SERVICE BULLETIN #1179

MODEL 1-92

DATE 6/6/62

SUBJECT New Cylinder Crankcase Assembly, P/N 58551 and Reed Valve Plate, P/N 57656B

←Reed Valve Plate, P/N 57656B

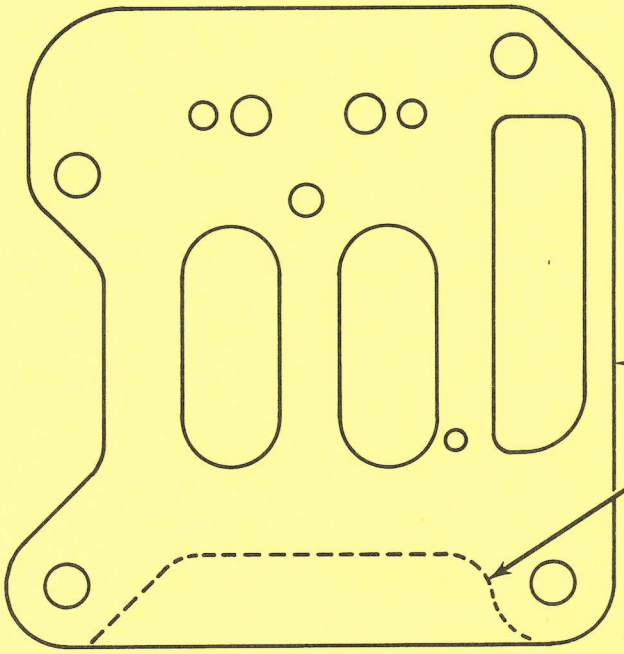
Cylinder Crankcase Assembly, P/N 58162, for Model 1-92 engines is no longer available. When required for service replacement, new Cylinder Crankcase Assembly, P/N 58551 (also used on Model 1-93 engines) will be furnished.

When ordering Cylinder Crankcase Assembly, P/N 58551, for Model 1-92 engines, new Reed Valve Plate, P/N 57656B, must also be ordered. The old reed valve plate (P/N 57656A) will not fit and cannot be used with the new cylinder crankcase.

Shape of old Reed Valve Plate, P/N 57656A, shown by dotted line.
